8 REPORTS DIRECT TO COUNCIL**8.1 PLANNING AND ENVIRONMENT****8.1.3 REQUEST TO CHANGE DEVELOPMENT APPROVAL AND CONDITIONS - MATERIAL CHANGE OF USE OF PREMISES (MULTIPLE DWELLING UNITS), "BREEZE", 3 META STREET, MOOLOOLABA**

File No: MCU14/0079.02

Author: Principal Development Planner
Planning and Environment DepartmentAttachments: Att 1 - Amended Plans 27 [↓](#)
Att 2 - Independent Architect's Report 49 [↓](#)

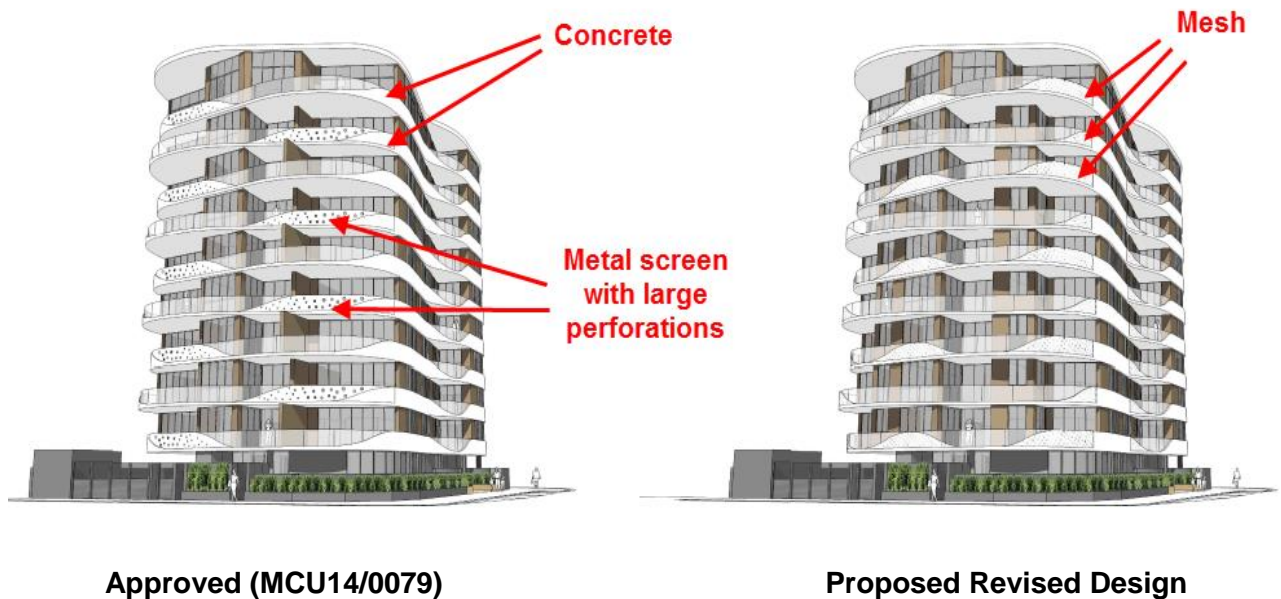
The balustrading to the north facing units fronting the Esplanade has been changed to reduce the extent of solid concrete and metal screening, and to provide a different style of metal screening. A larger extent of glass balustrade is now provided. A plan illustrating the proposed changes is included below.

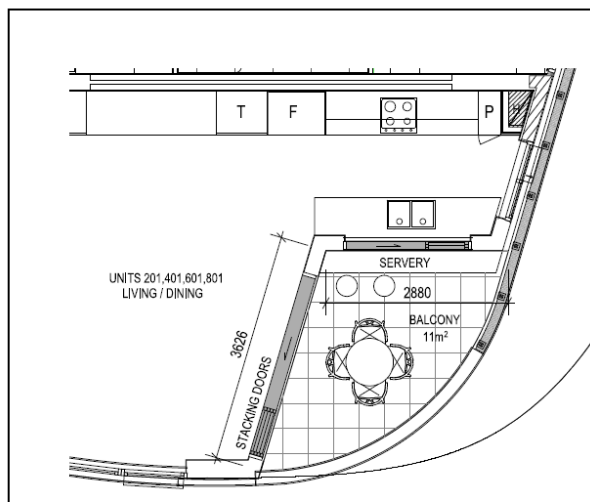
The balustrading is a critical part of the architectural features of the building. It articulates the horizontal curves of the floor plan in the vertical dimension, but also delivers a diagonal ripple effect, which is a subtle but important effect. While not explicitly mentioned in the DA material, the design of the balustrading accounts for an important part of the building’s design merit, which according to officers mitigated the site cover and setback issues outlined in PO8 of the Multi Unit Res Code.

In respect of the balustrading, it is considered that the originally approved balustrading strongly articulates the alternating horizontal curves of the building. This aspect of the design significantly contributed to the overall quality of the design outcome and provided some justification for the development not meeting certain acceptable outcomes of the Multi-unit residential uses code (site cover, setbacks) at the time it was originally assessed by council officers. The balustrading also provided privacy screening to the smaller Type A balconies. The proposed balustrading does not articulate the horizontal curves of the building to the same extent as the approved balustrading, and provides minimal screening to the smaller Type A balconies. If the applicant had made a request to change the development approval prior to the building being built, council's delegate would most likely have not approved the proposed changes to the balustrading.

As this aspect of the building is reasonably easy to correct, Council should vigorously pursue the reinstatement of the balustrading. Negotiations with the applicant should seek:

- 1. Reinstatement of the screen balustrading to achieve the diagonal ripple effect;*
- 2. The use of a larger perforated metal balustrade to deliver the original ‘playfulness’ of the building and increase privacy to the balconies; and*
- 3. While it is unrealistic to expect the extent of concrete balcony to be increased, Council should ensure that any joins between metal and concrete balustrading are consistent with the curved join in the approved design.”*

BALCONY DETAIL PLAN
SCALE 1:60 @ A3

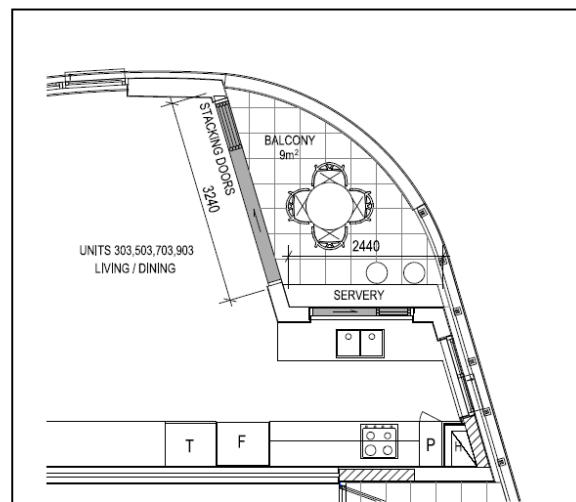
The applicant has calculated that the sizes of the above balconies are 11m² and 9m². It should be noted that council officers have calculated the sizes are actually 9.65m² and

8.41m² if measured to the outside edge of the balcony slabs and if the serveries are included in the calculation (in other words, a “best case” measurement).

The kitchen extensions are inconsistent with the approval. The outcome for balcony Type A is in conflict with PO11 of the Multi Unit Res Code which stipulates “a balcony or similar private open space area directly accessible from the main living area which is not less than 12sqm in area with a minimum dimension of 3.0m”. It is correct that the approval locked in a balcony width of approximately 2.35m for Balcony Type A (less than the AO11.4). However given glazing could be opened for almost the full length of this balcony allowing the room full exposure to the deck, then the outcome would have maintained a high degree of amenity, and could be considered consistent with PO11.

The impact of the kitchen extensions on Balcony Type C is also not consistent with the Purpose and Overall Outcomes of the Multi-unit Res Code as it delivers a useable balcony area of only 6sqm as the rest can be overlooked and is unshaded.

- 4. Consider not approving kitchen extensions on Type A balconies; and*
- 5. Condition colour and materials to kitchen extension on Balcony Type C that reinforce the horizontal banding intended in the original approval.”*

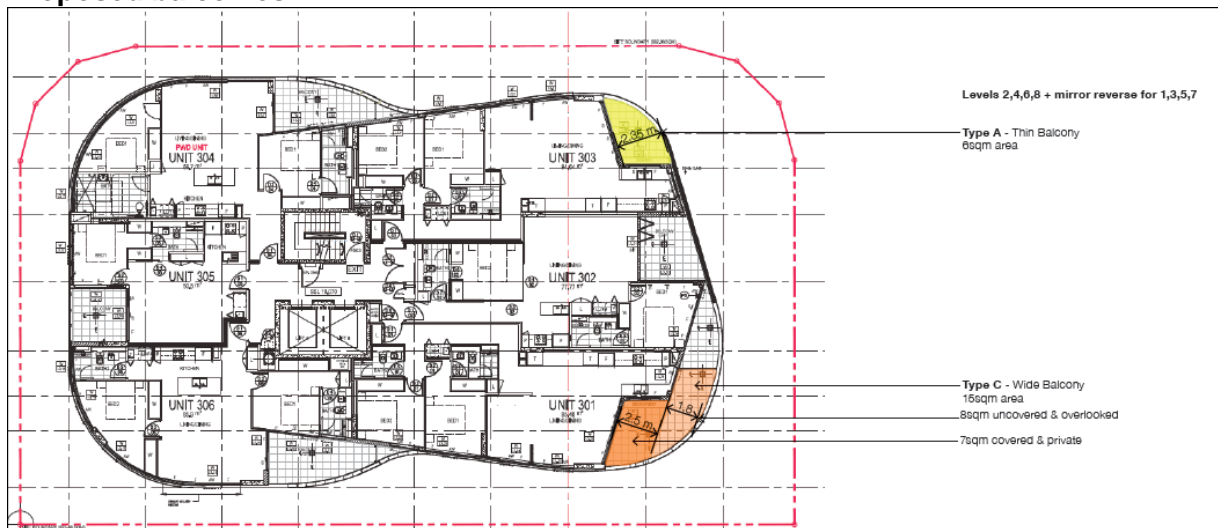
Having regard to the applicant’s additional representations, and the advice from Deicke Richards, it is considered that the kitchen extensions do not create a significant adverse impact on the built form and appearance of the approved building. The approved building already included a bedroom that extends forward of the Esplanade face of the building (one bedroom per floor above ground level, and two at the penthouse level), and this bedroom, together with the party wall separating two balconies per floor, already provides some interruption to the horizontal flow of the design. The inclusion of two kitchen extensions per affected floor, one immediately adjoining the approved bedroom extension, and one immediately adjoining the approved party wall, does not change the appearance of the building significantly.

However, it is considered that the kitchen extensions do create a significant adverse impact on the size of the approved balconies, with the greatest impact occurring on the smallest balcony type (Type A – yellow) as illustrated on the Deicke Richards sketches below. The kitchen extensions also impact on the usefulness of the larger balcony type (Type C – orange) because this balcony is partially uncovered and overlooked from above.

The smallest proposed balcony type (Type A – yellow) does not meet Acceptable Outcome 11.4 (AO11.4) of the Multi-unit residential uses code, which requires each dwelling unit above ground level to have a balcony or similar private open space area that is directly accessible from the main living area, and which is not less than 12m² in area with a minimum dimension of 3m. The larger proposed balcony type (Type C – orange), although partially uncovered and overlooked from above, generally meets AO11.4 and the related Performance Outcome PO11.

The approved Type A balcony was 13.3m² in area and, although it was less than 3m deep, this was mitigated by the operable wall extending for approximately 6m, and effectively for the full length of the living/dining/kitchen area. In comparison, the proposed Type A balcony is calculated to be 9.65m² and 8.41m² in area, and 2.88m and 2.44m deep at its greatest depth (the size and depth alternates between floors).

It is considered that the proposed Type A balcony is deficient for the 2-3 bedroom units and would not meet Performance Outcome PO11 of the Multi-unit residential uses code in that future residents will not have sufficient area to enjoy private and semi-private spaces and accommodate visitors.

If the applicant had made a request to change the development approval prior to the building being built, council's delegate would most likely have approved the kitchen extensions into the Type C balconies, but would most likely have not approved the kitchen extensions into the Type A balconies. In other words, one kitchen extension per floor would have been approved in lieu of the two kitchen extensions per floor sought (i.e. 8 out of 16).
